Preliminary Acceptance (PA) Punchlist
EPC - DPW - Stormwater Section

Project Name:	Hills at Lorson Ranch
EDARP Filing Number(s):	SF2110, PUDSP203, CDR207, PUDSP216
ESQCP Number:	ESQ2033
Attendees:	DPW SW: Natasha Grimaldo, Ben Jones DPW Planning: N/A Developer: Jeff Mark/Lorson LLC
Date of Walk-Thru:	3/6/2023
Walk-Thru Number:	1st

Photos:

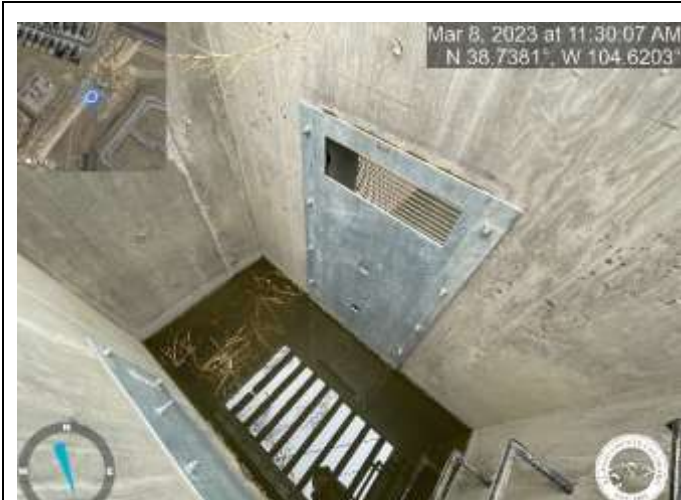
Photo 1: Pond C1: Orifice plate was not properly installed. Invert of the bottom most hole should be at the same elevation as the invert of the outlet pipe.
